Work Order ID 97861

Item Name: Crosstube Turning Detail

DART AEROSPACE LTD	Work Order:	97861
Description: Crosstube Assembly (205/212/412 High Fwd)	Part Number:	D212-664-141
Inspection Dwg: D212-664-141 Rev: D		Page 1 of 2

DRAWING NO. D212-664-141	TITLE XTUBE ASSY (205/212/412 HI FWD)	REV. D	DART AEROSPACE LTD ENGINEERING ORDER		D.E.O. NO. D212-664-141-D-1	SHEET NO. SHEET 1 OF 2	SCALE NTS
DRAWN	CHECKED	MFG. APPR.	APPROVED	DE APPR.			
DATE 11.04.07	DATE 11.09.11	DATE 11.04.12	DATE 11/09/12	DATE 11.04.12

**D212-664-141/-141B
ASSEMBLY DETAIL**

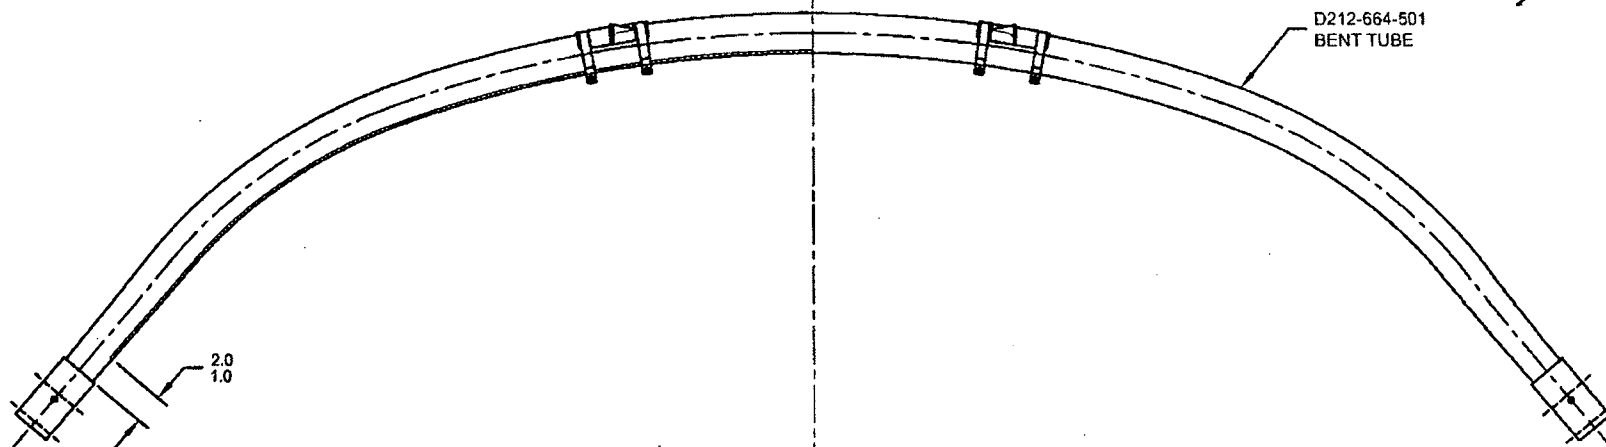
PURPOSE:

ADD AN INSPECTION WINDOW TO UNDERSIDE OF CROSSTUBE.

NOTES 2 OF SHEET 1 IS AMENDED AS FOLLOWS:

- 2) FINISH: CHEMICAL CONVERSION COAT PER DART QSI 005 4.1
PRIME INSIDE AND OUTSIDE PER DART QSI 005 4.2
MASK UNDERSIDE OF CROSSTUBE AS SHOWN (HATCHED AREA) AND
PAINT OUTSIDE PER DART QSI 005 4.2
REMOVE MASKING AND APPLY CLEAR COAT

MASK AREA PRIOR TO PAINTING.
REMOVE MASKING AFTER PAINT
AND APPLY CLEAR COAT
